**Addendum # One (1)**

**Project** Multicultural Center Roof Terrace  
Ball State University  
Project # 2023-022.01 MC

**Date:** May 10, 2023

**A301**

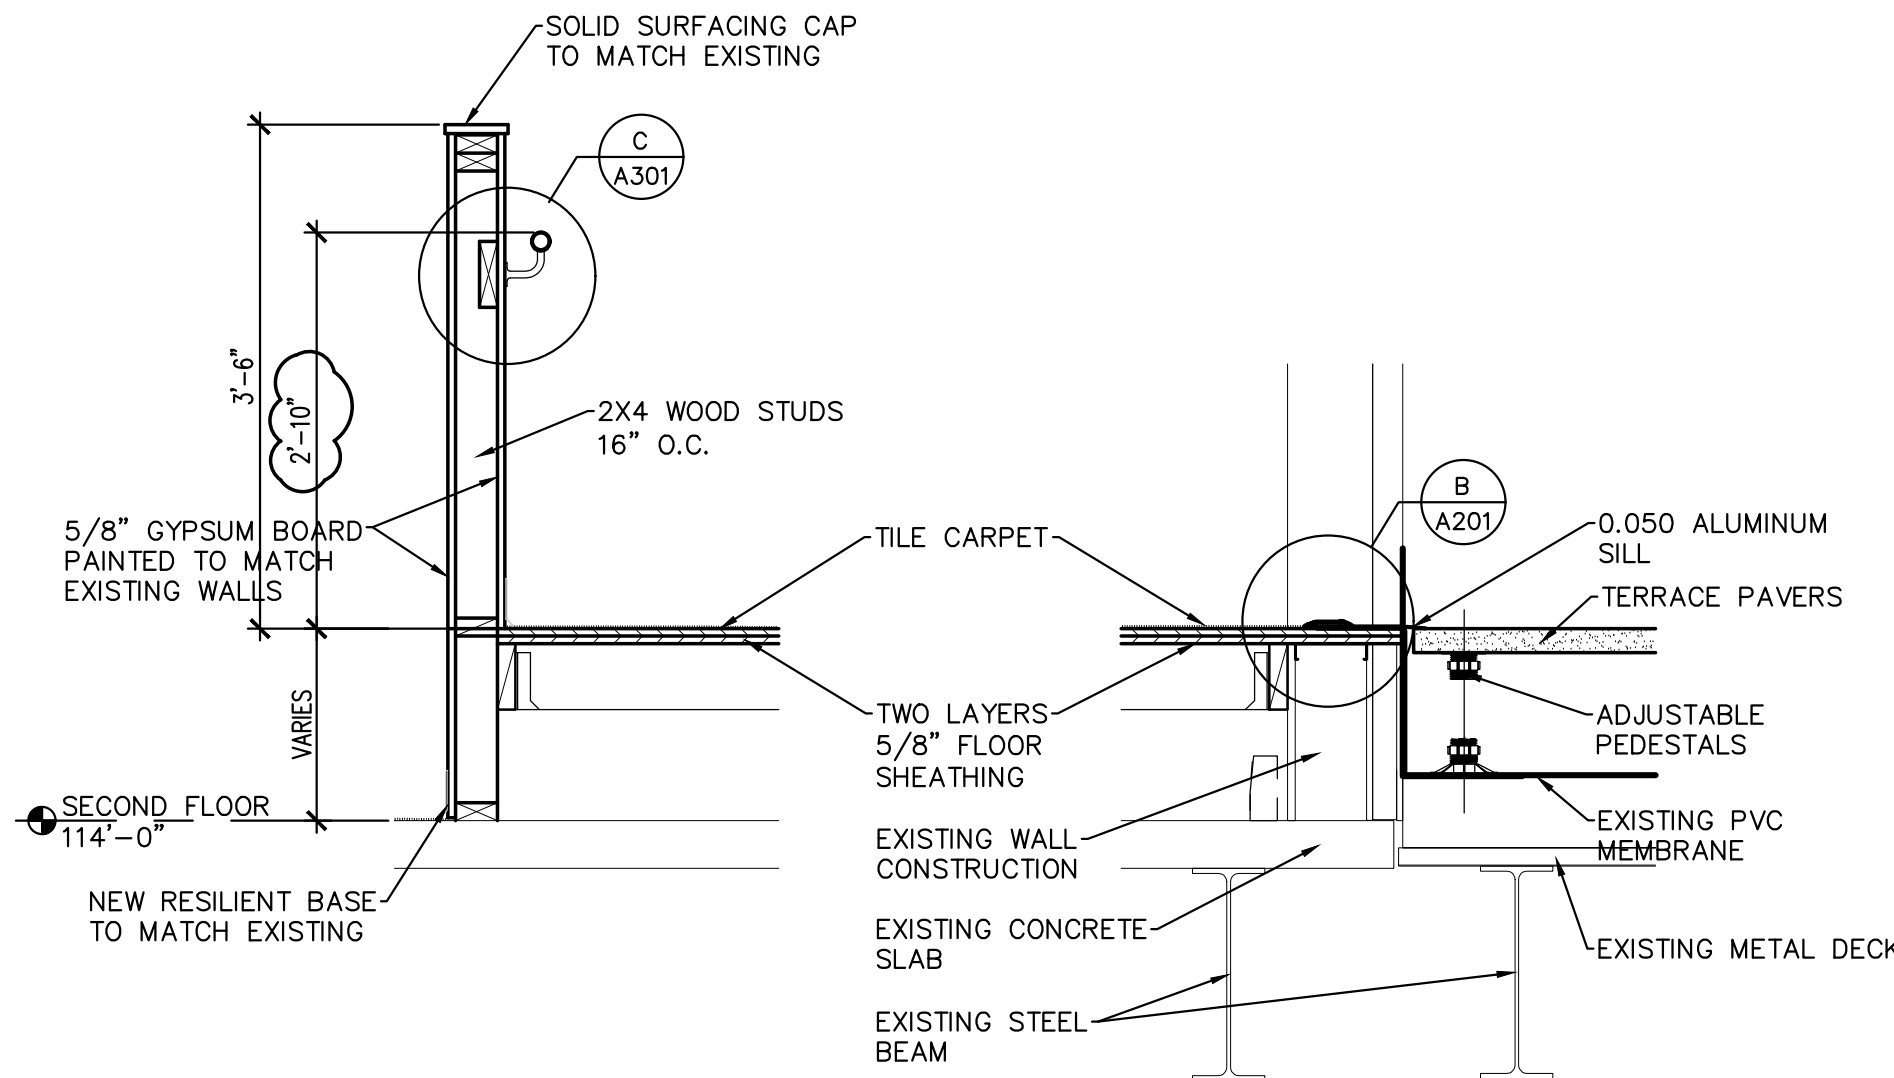
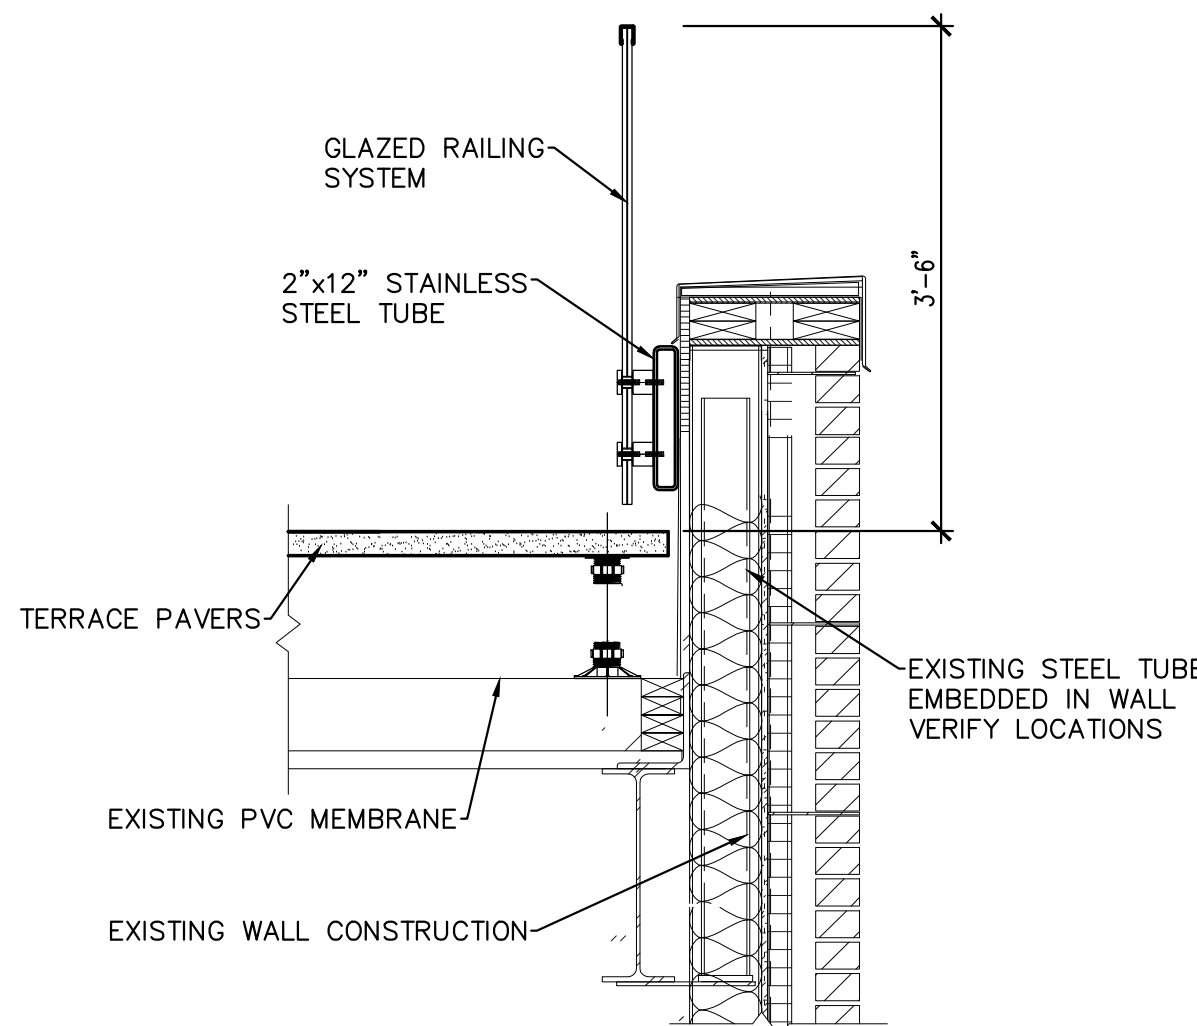
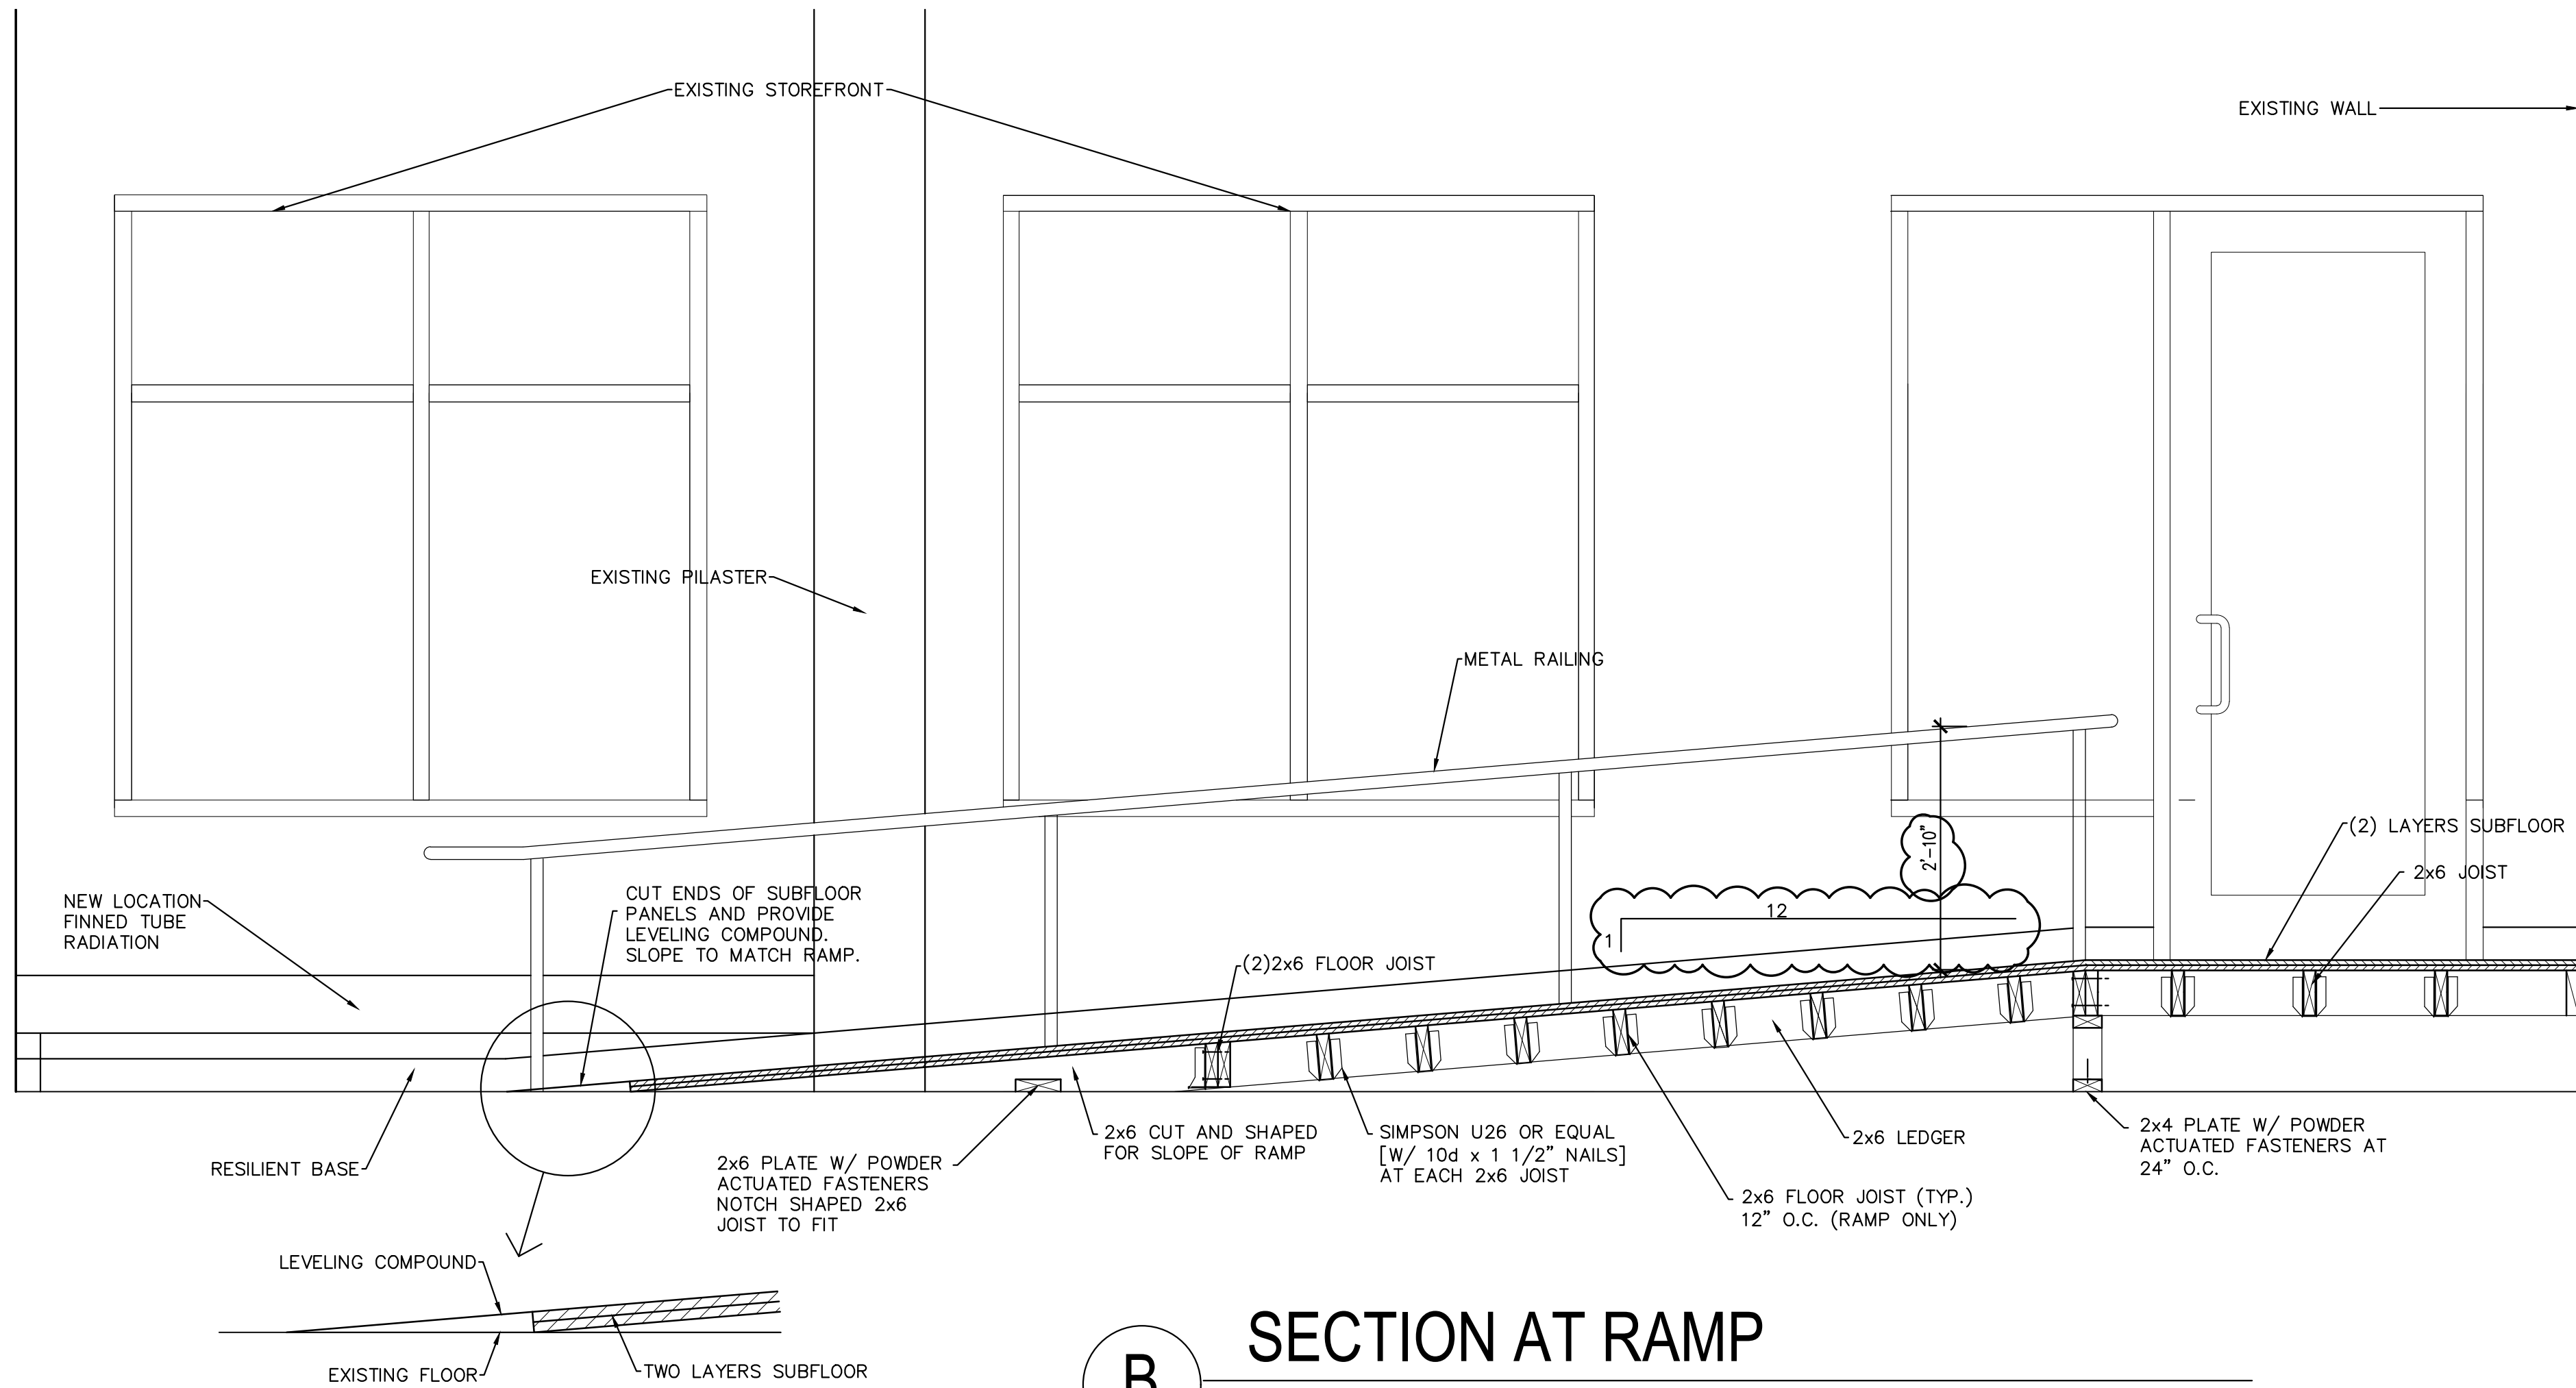
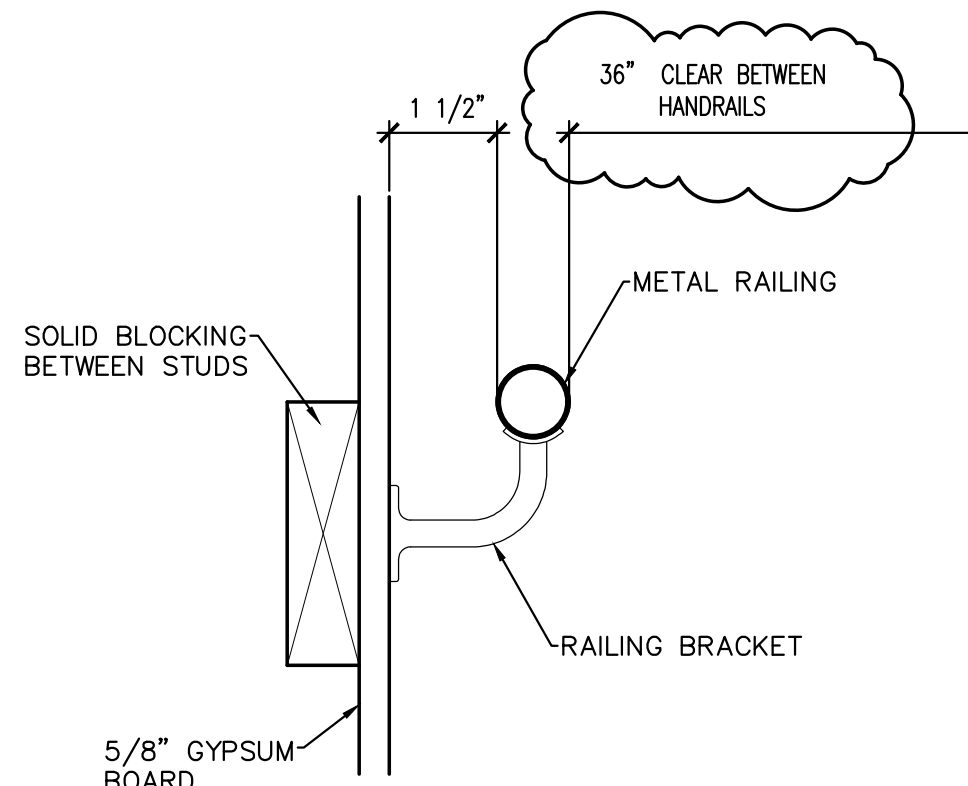
1. See revisions Sheet A301, attached.
